Renewed License No. DPR-32
Amendment No. 250

Amendment Nos. 250, 249

SURRY TECHNICAL SPECIFICATION CURVE FOR CONTAINMENT
ALLOWABLE AIR PARTIAL PRESSURE INDICATION VS. SERVICE WATER TEMPERATURE

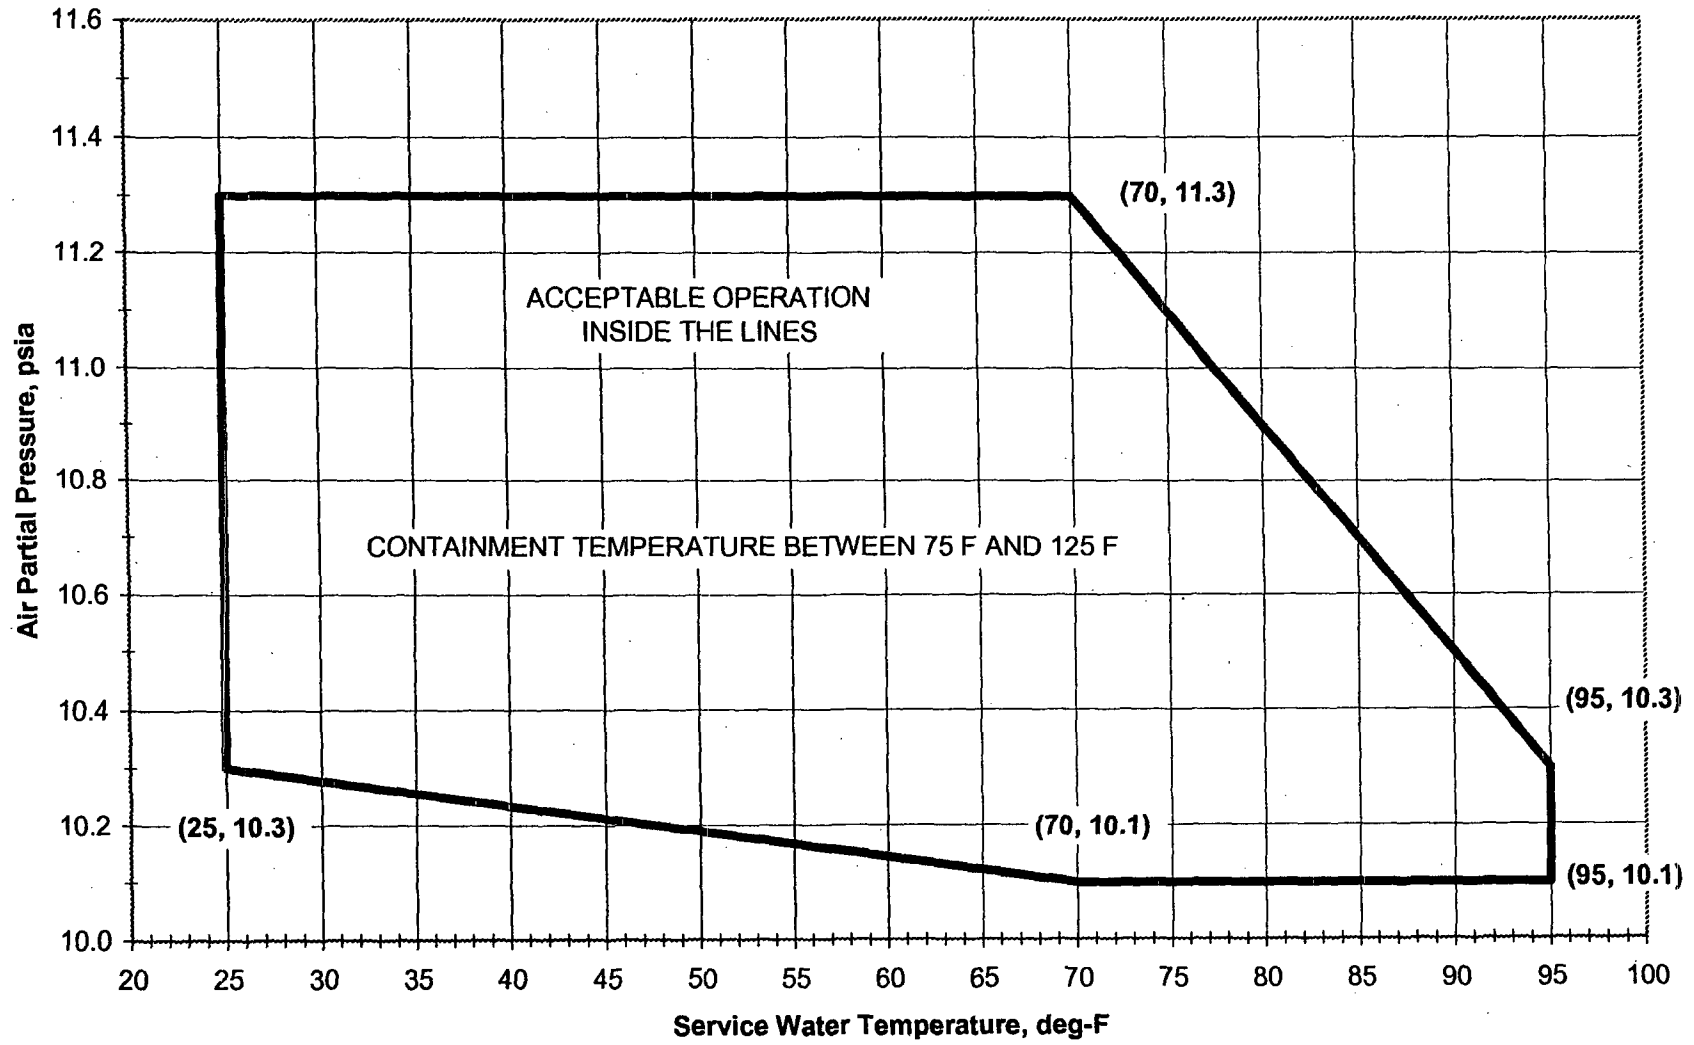
The allowable value for the containment air partial pressure is presented in TS Figure 3.8-1 for service water temperatures from 25 to 95°F. The RWST water shall have a maximum temperature of 45°F.

The horizontal upper limit line in TS Figure 3.8-1 is based on MSLB peak calculated pressure criteria, and the sloped line from 70°F to 95°F service water temperatures is based on LOCA depressurization criteria.
